DOE/NASA/20320-63
NASA TM-86983

Government Review of the Mod-2 Wind Turbine (As-Built)

A Government committee was formed to conduct an as-built review of the three Mod-2 wind turbine units at Goldendale, Washington. The purpose of the review was (1) to identify any critical components and subassemblies which may be deficient in either strength or predicted service life, the failure of which would cause safety hazards or significant downtime and expensive repairs; and (2) to recommend any corrective action necessary to enable continued safe attended and unattended machine operation.

Figure 5. - Teeter bearing housing.

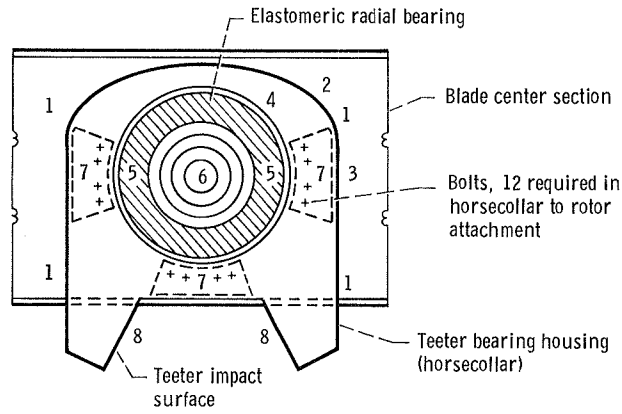
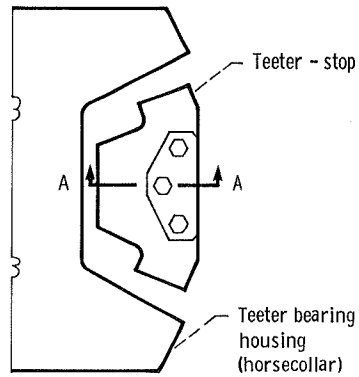
- (1) Iron oxide stains, indicating fretting at the horsecollar-to-rotor spar interface, were observed at location 1, figure 5, on all five Mod-2's.
- (2) Evidence of plastic shim failure was observed at location 7, figure 5, on WT4 and WT5.

- (3) Poor fit up (gap) at horsecollar-to-rotor spar interface was observed at location 3, figure 5, on WT5.
- (4) Weld flaws were observed at location 4, figure 5, on WT4; and a possible weld crack at the same location on WT2.

- (5) Surface cracks were observed on the elastomeric radial bearing at location 5, figure 5, on WT4.
- (6) A gap was observed at location 6, (see fig. 5) on WT4 between the elastomeric thrust bearing and rotor spar for the lower thrust bearing with the rotor horizontal, indicating a significant reduction in preload.

- (7) The bolts, location 7, figure 5, used to attach the horsecollar to the rotor, were torque checked. The torque measurements were lower than the original torque values at assembly.

- (8) Evidence of high teeter-stop loads at location 8, figure 5, were observed on WT5. This was presumably a result of nonoperating rotor-teeter motion in winds above cut-out velocity.

- (1) Design, fabricate, and install a teeter motion damper
- (2) Replace plastic shim between horsecollar and rotor with steel shim
- (3) Determine cause of loss of preload in thrust bearing and take corrective action

Figure 6. - Teeter-stop details.

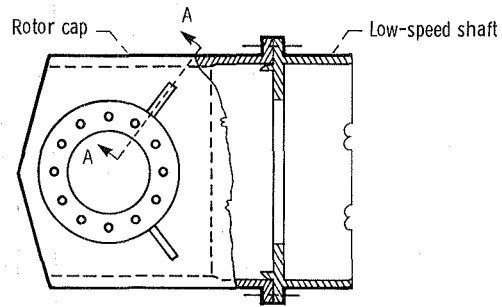
- (9) Analysis showed that the preload on the teeter-stop fitting bolts, figure 6, was insufficient to prevent slippage of the fitting.

(View A-A)
Figure 7. - Rotor cap details.

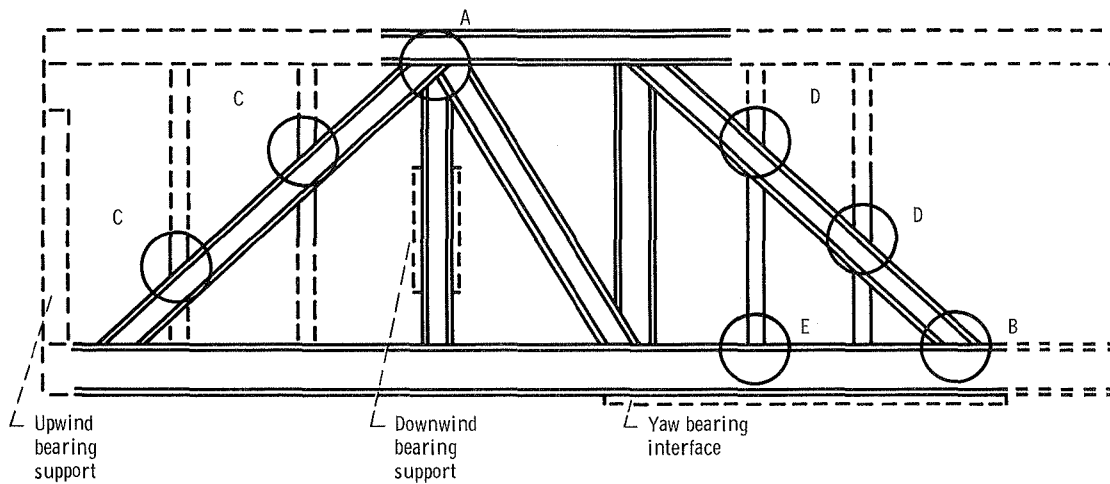
The Government inspection found 8, 0.5-in-diameter holes drilled through the cylindrical wall of the rotor cap at station 1 and station 19 as shown in the BEC drawing 032-418000. The purpose of these holes is for inserting bolts used to secure hydraulic line brackets. Structural analysis of the rotor cap to take into account the effects of these holes on the structural integrity of the rotor cap was not done.

- (1) Increase bolt size and preload at low-speed shaft-to-rotor cap interface
- (2) Install additional gusset plates, as required, at trunnion and rotor cap intersection weld
- (3) Repair or redesign pilot interface
- (4) Grind fillet weld wrench marks and increase washer thickness to provide adequate clearance

Figure 8. - Nacelle and major bearing support details.

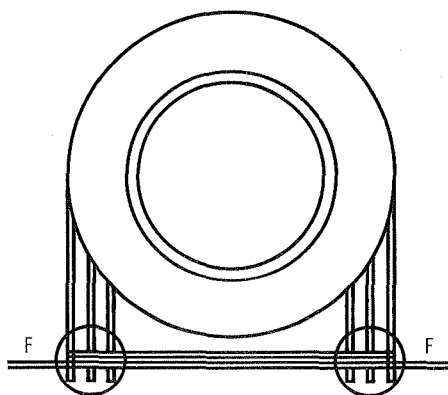
Findings: Inspection of the downwind bearing supports, shown in figure 8, indicated the following:

A visual inspection of critical weld areas in the nacelle did not identify any failures. The fatigue analysis estimated "time to repair" values varying from 6 mo to 10 yr as shown in figure 8. The analysis was based on the assumptions listed in appendix D.

Figure 10. - Metal slivers removed from yaw ring gear.

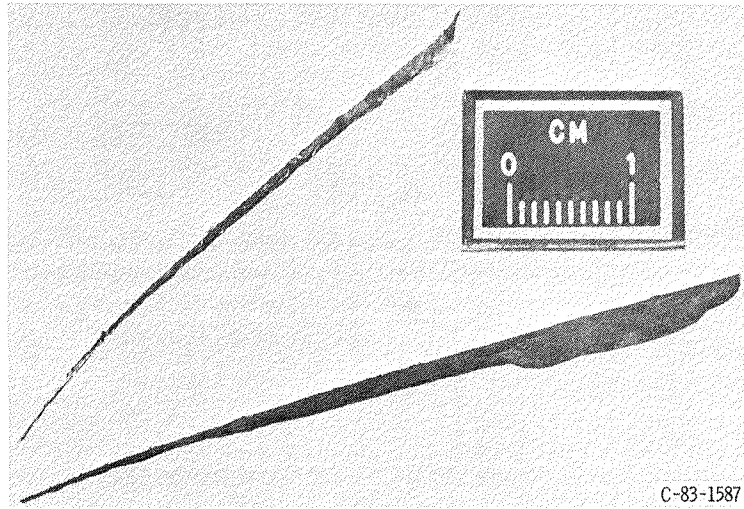
The pinion gear specification calls for heat treatment to BHN 350/425. The ring gear specification calls for heat treatment to BHN 250/300. With the pinion gear having the harder surface, alignment and tooth surface contact become very important. Without proper alignment and tooth contact, excessive wear and possible tooth breakage can occur. Slivers of metal, as shown in figure 10, were removed from one ring gear.

Figure 11. - Yaw drive motor pressures during yaw corrections. (Rotor speed = 17.5 rpm.)

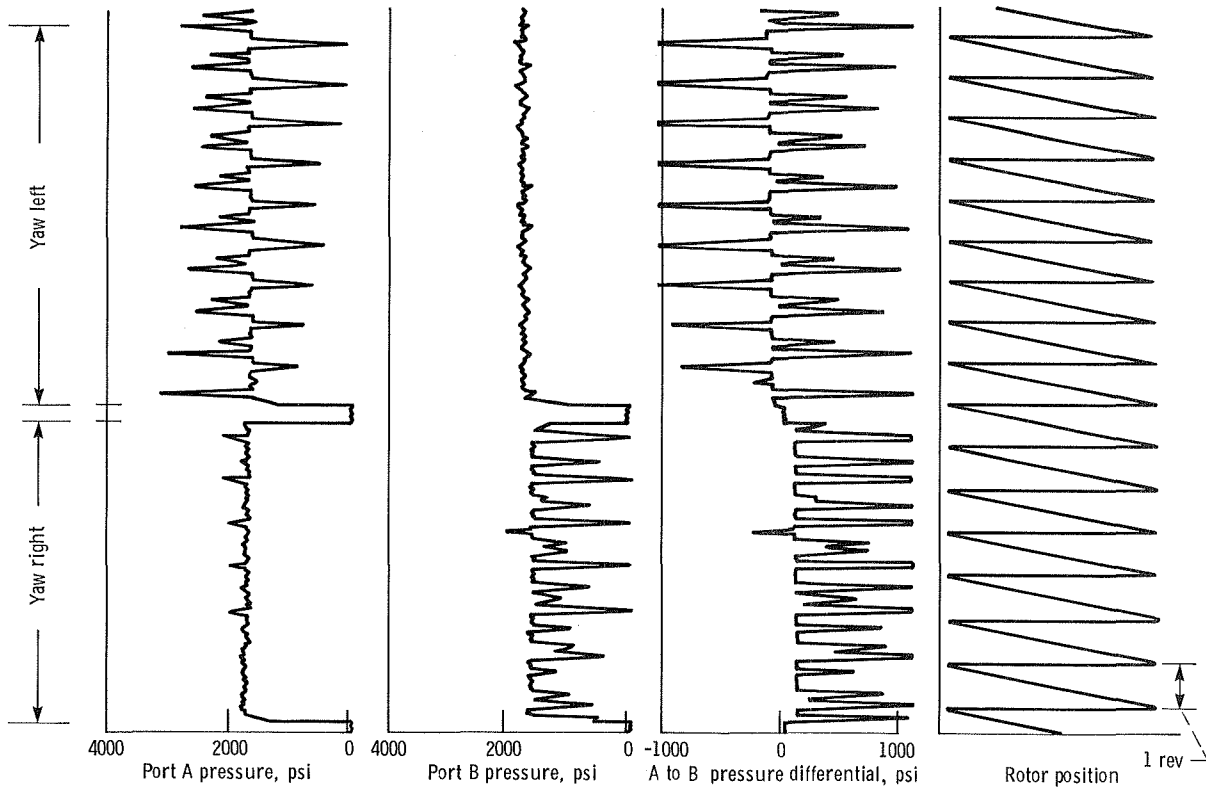
During Mod-2 operation, just prior to the low-speed shaft failure, measurements of hydraulic pressure at the yaw drive motor ports were made. These measurements, shown in figure 11, showed pressure impulses of close to 2000 psi (system design pressure) when yawing took place while the rotor was at normal operating speed (17.5 rpm). If yawing took place when the rotor was coming up to operating speed, higher peak impulse pressures were observed. The impulsive nature of the pressure measurements is a result of the cyclic yawing moments produced by the rotor and backlash in the gear teeth. Because of the backlash, the nacelle can rotate through a small angle unrestrained except for friction in the yaw bearing. This motion continues until the ring gear impacts the pinion gear causing a pressure spike in the drive motor.

These pressure measurements provide evidence that the yaw drive system was being subjected to loading that was not considered in its design. Design torques for the yaw drive gearbox were 11 600 ft-lb steady and 37 500 ft-lb limit. There was no specification for cyclic loading. Estimated actual loading was based on yaw drive motor pressure measurements. Measured steady or mean torque was about 5000 ft-lb and measured cyclic peak torque was about 32 500 ft-lb. The frequency of the cyclic torque was about one per rev, instead of the anticipated two per rev, indicating blade-to-blade imbalance. The effect of this loading on yaw gearbox life has not been assessed.

Figure 12. - Solano (WT5) tower crack, view looking east. (Subsurface defects are directly below surface defects.)

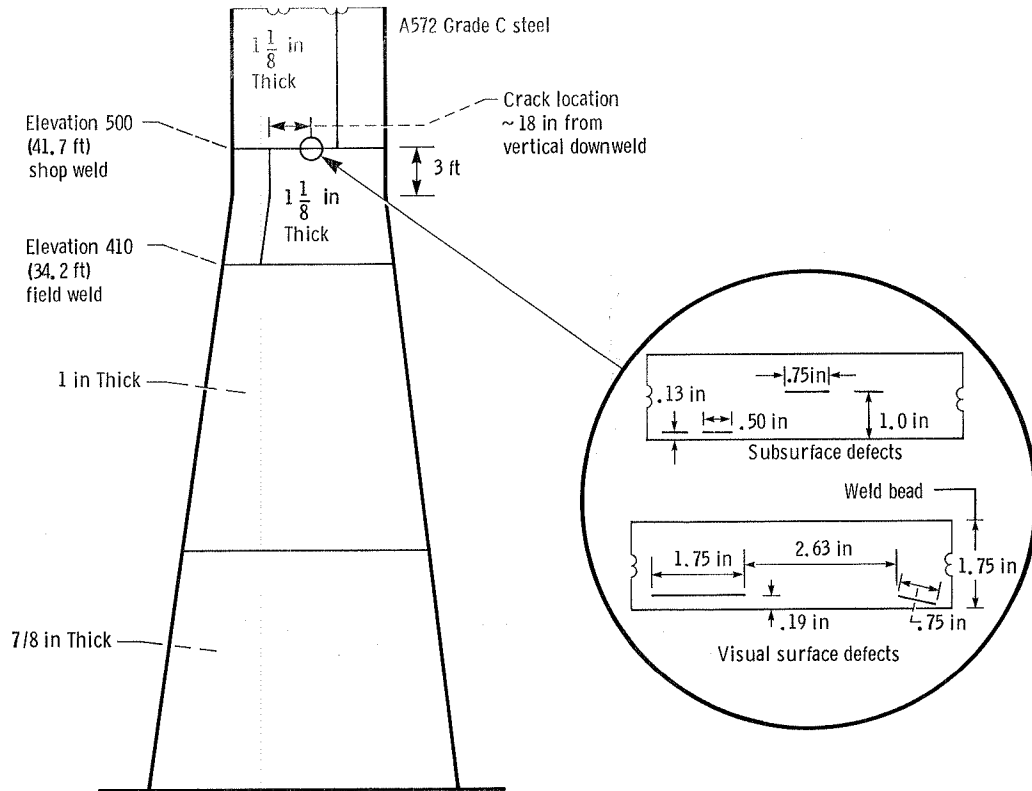
Findings: It is important to note that the Solano flaw, shown in figure 12, was first detected by an observation of rust stains on the exterior surface of the weld. Furthermore, this observation made by a BEC individual involved in another site assignment, proves that a 1.75-in crack can be detected by a visual inspection.

- (1) Audit all radiographs now in existence and/or reradiograph
- (2) Remove all reinforcement from the inside welds and penetrant inspect
- (3) Visually inspect tower every 600 hr

Figure 14. - Gin pole system.

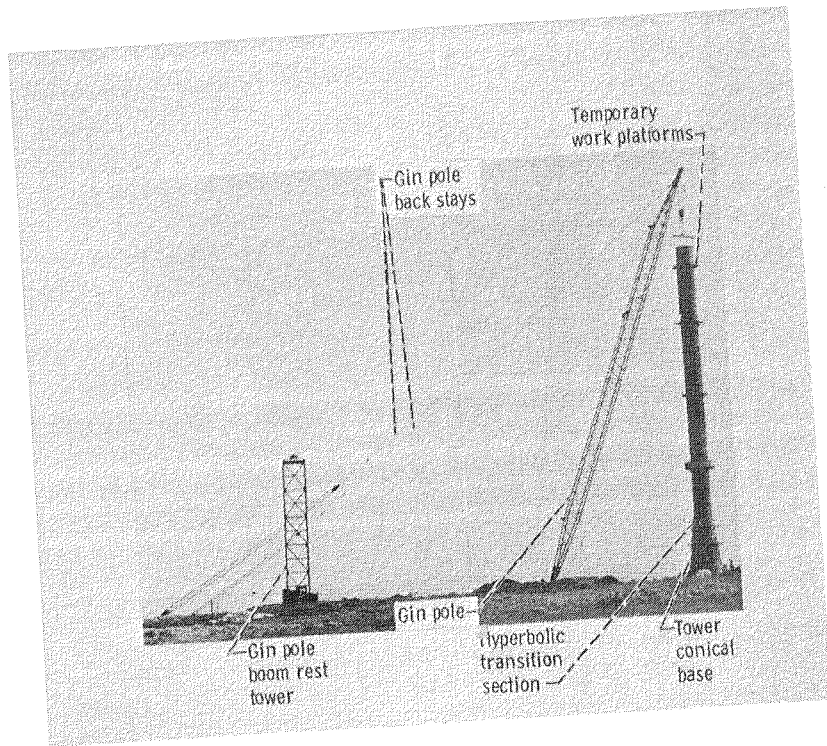
Findings: The gin pole system has performed satisfactorily to date except for a failure of a backstay anchor plate on WT1. Fortunately, the failure did not occur during a lift but while the cables were being straightened with the boom on the boom rest. The anchor plate failed because it was subjected to offset loading not considered in its design. All anchors were subsequently modified to handle offset loading.

Due to an increase in the weight of the new low-speed shaft design of 10 250 lb, additional weight must be added to the proof load test assembly to meet the requirements of ANSI B 30.7-1977, para 7-2.2.2.

- (1) Add additional weight to the existing gin pole proof load to compensate for the increase in weight from modifications including new low-speed shaft assembly
- (2) Incorporate formal gin pole Operations and Maintenance procedures which include assembly, disassembly, operation, proof test loads, maintenance, inspection, and corrosion prevention in the Operations and Maintenance manual
- (3) Provide environmental protection of the gin pole winch assembly

Figure 16. - Rotor spindle assembly.

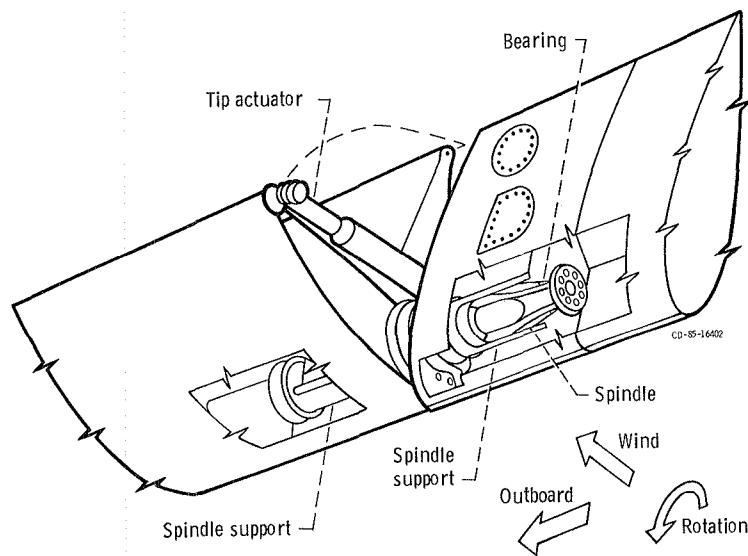
Concern: The overall concern questioned the strength of the actuator rod-end bearing assembly, and the resultant blade tip motion if this assembly should fail.

Findings: The bearing preload was maintained by six Belleville spring washers installed on the rotor spindle in two stacked sets of three washers for each blade. These washers were installed as specified on Boeing drawing 032-411311 and bench calibrated for exact stack height versus 168 000-lb design preload. Each match stacked set was cycled through a minimum of four, 0 to 168 000-lb loads, versus measured heights. Data reviewed showed excellent consistency or uniformity of spring rates (nominally 400 000 lb/in) with a maximum deviation of 0.001 in between the four heights measured during the calibration bench tests. The stacked height measurement is then permanently stamped to the rotor-spindle flange for the respective Belleville washer set installed. Each set is lubricated with grease during final installation to prevent corrosion.

An inspection of the flange face of the blade midsection to which the rotor spindle assembly mates revealed that several of the tapped holes had been modified with threaded inserts. These were used because the original threads were stripped during handling operations prior to shipment to the site. This handling was accomplished by using too few bolts for the load, and thus the threads were stripped. If all bolts had been used in maneuvering the blade, no problem would have occurred. In any event, the use of inserts does not degrade the structural integrity or load capacity of an individual hole. However, as a precautionary measure, a recommendation for inspection of these inserts has been made.

- (2) Replace the plastic shim material between highly preloaded flange faces with steel material
- (3) Inspect the flange to determine if inserts provide a satisfactory long-term repair

Figure 18. - Gearbox details.

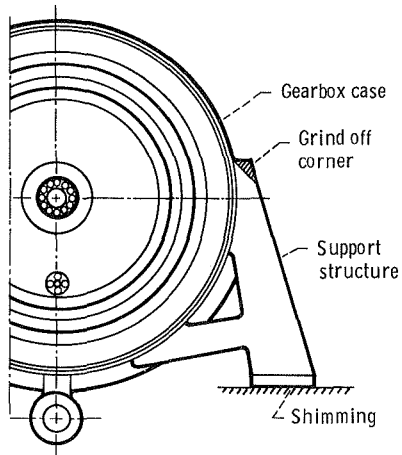
Findings: The gearbox, shown in figure 18, has proven trouble free with only a few instances of lubricating oil leakage. The overspeed incident has shown it to be capable of sustaining high overloads without damage. During the incident, input torque reached 3.96×10^6 ft-lb or 360 percent of rated torque, compared to the design limit torque of 1.65×10^6 ft-lb.

Dye penetrant inspection and strain gauging of the suspect weld on the Mod-2 gearbox revealed no problems. However, analysis showed that stress could be reduced by minor rework of the weld detail.

- (1) Rework the detail at the intersection of the gearbox case and support structure to reduce stress in the weld

Figure 19. - High-speed shaft.

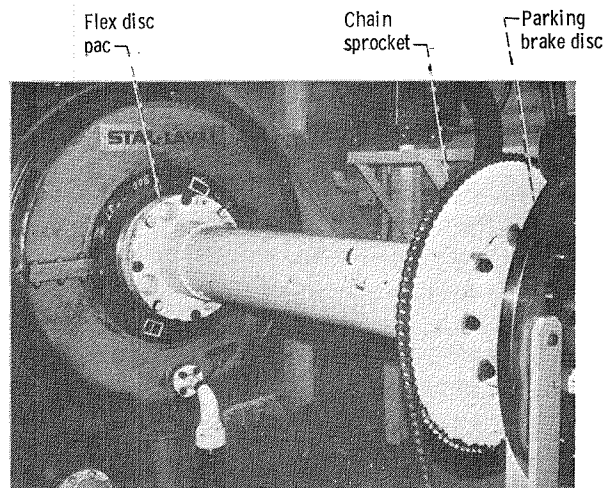
Item No. 14 - High-Speed Shaft. - The high-speed shaft (HSS), shown in figure 19, transmits torque from the high-speed end of the gearbox to the generator. This hollow shaft incorporates disc pack flexible couplings at both ends and a chain drive sprocket. The chain sprocket is used in conjunction with an electric motor and gearbox to position the rotor for maintenance and inspection.

- (1) Show holes, used to fasten balance weights to the shaft, on the respective drawings

Figure 20. - Typical induction disk relay.

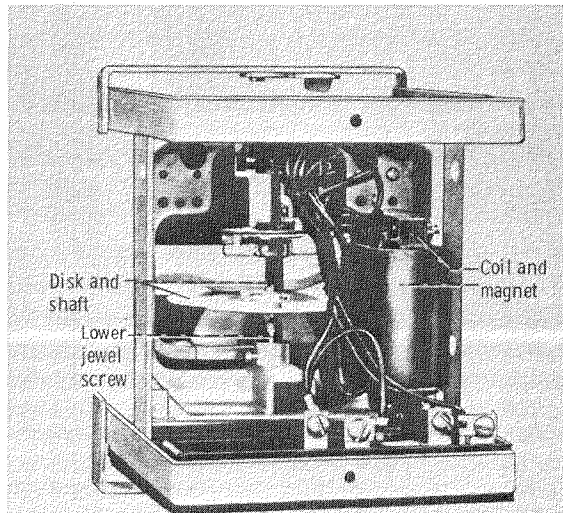
Concern: The vibration environment might change calibration or cause failure of the relays. Relay failures could result in loss of the electrical power system protection for the wind turbine generator.

Findings: All eleven induction disk and induction cup relays were removed by BPA from the GAU cabinet of WT2 for investigation of calibration and environmental effects. They were each bench operated to verify acceptable response. Seven relays were checked for calibration drift. These relays were found to be within acceptable tolerance of the original calibration points (see table II).

Five of the induction disk relays were opened to permit examination of the shaft, bearing, and bearing surface. Figure 20 shows a back view of a typical induction disc relay. The disk is mounted on a vertical shaft which pivots on upper and lower pins. The top bearing consists of a pin in the relay body which fits into a sleeve insert in the shaft. The bottom bearing consists of a pin which protrudes from the bottom of the disk shaft that rides on a jeweled surface. The disk is actuated by an induced magnetic field. The disk shaft is restrained by a spiral spring and its motion is retarded by a permanent magnet acting on the disk to give the correct time delay. The differential relay (87) and the loss of excitation relay (40) were not opened for examination because of the difficulty to "tear down".

Figure 25. - Overspeed sensing circuitry.

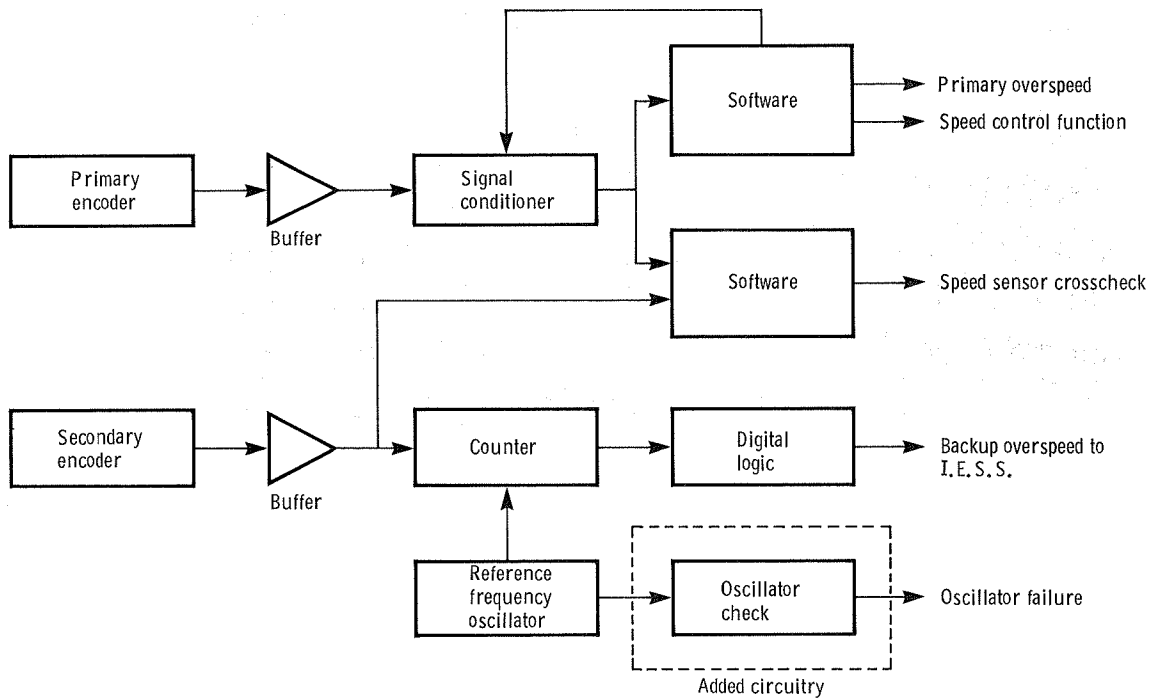
Findings: The overspeed protection was analyzed through a review of the schematic drawing (BEC 032-457013 sh-1 and 032-457025 sh-2) and a discussion of maintenance procedures. Circuit analysis was performed by BEC and NASA.

The sensing, shown in figure 25, consists of two encoders of similar but not identical installation and manufacture, thus eliminating the likelihood of simultaneous generic failures. One sensor used for the speed control function, also generates the primary overspeed signal which actuates the start and stop valves. This circuitry, located in the microprocessor rack was used continuously during normal running. Thus, most failures were detectable and failsafe or had a built-in backup mode, such as feathering the blade with servo valves if the start and stop valves did not function.

Figure 26. - Wind turbine control communications link.

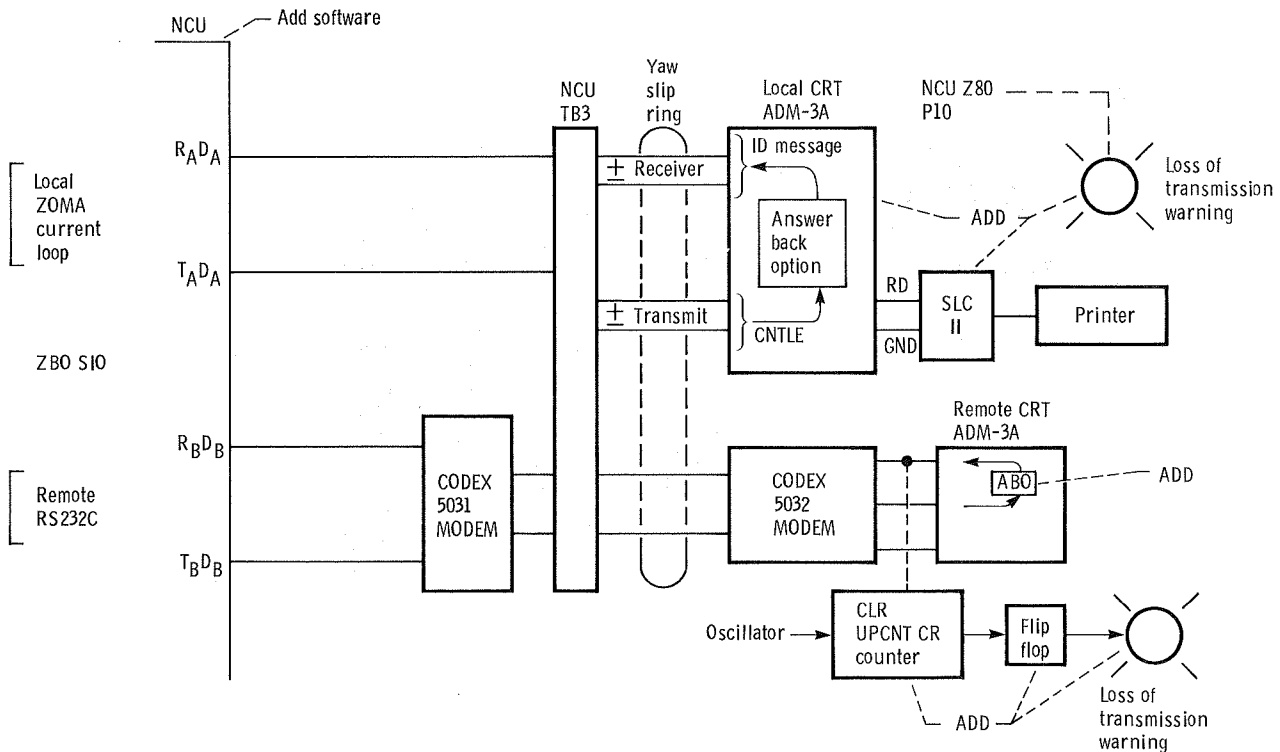
An answerback feature could be added to the CRT display terminal (see figure 26). Software added to the NCU would send a signal to the local and remote CRT's, which would echo back an ID message response to the NCU. If the answerback loop is broken, then an alarm is initiated at the local and remote terminals. A message counter would be added to the remote receiver line to power the remote alarm. This scheme will check all wires and circuits of the transmit and receive serial links for proper function.

- (1) Add answerback feature hardware and software to the display terminals

Figure 28. - Wind turbine yaw slipring anti-rotation restraint.

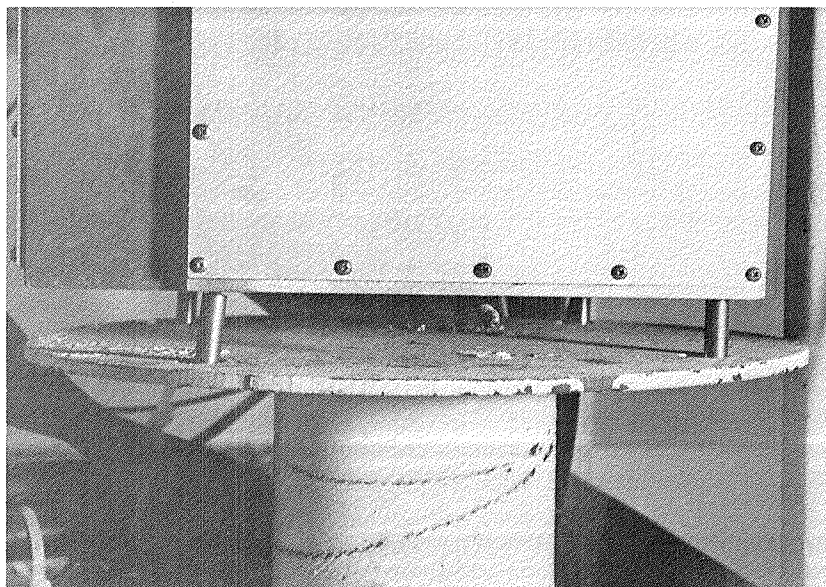
The antirotation bracket on WT2 (see figure 28) showed some deformation where the existing bolts, that act as antirotation restraints were attached. Inspections of this installation and others give the impression that misalignment might exist between the rotating and stationary fixtures of the yaw slipring assembly. This could cause bending loads to be placed on the assembly by the antirotation brackets and bolt restraints.

- (1) Inspect the sliprings for contamination and measure resistance on the power rings
- (2) Inspect and replace the molded HV cable termination boots as required, and install a drip shield to prevent further oil contamination
- (3) Replace the existing antirotation restraint with an improved design which can not load the yaw slipring
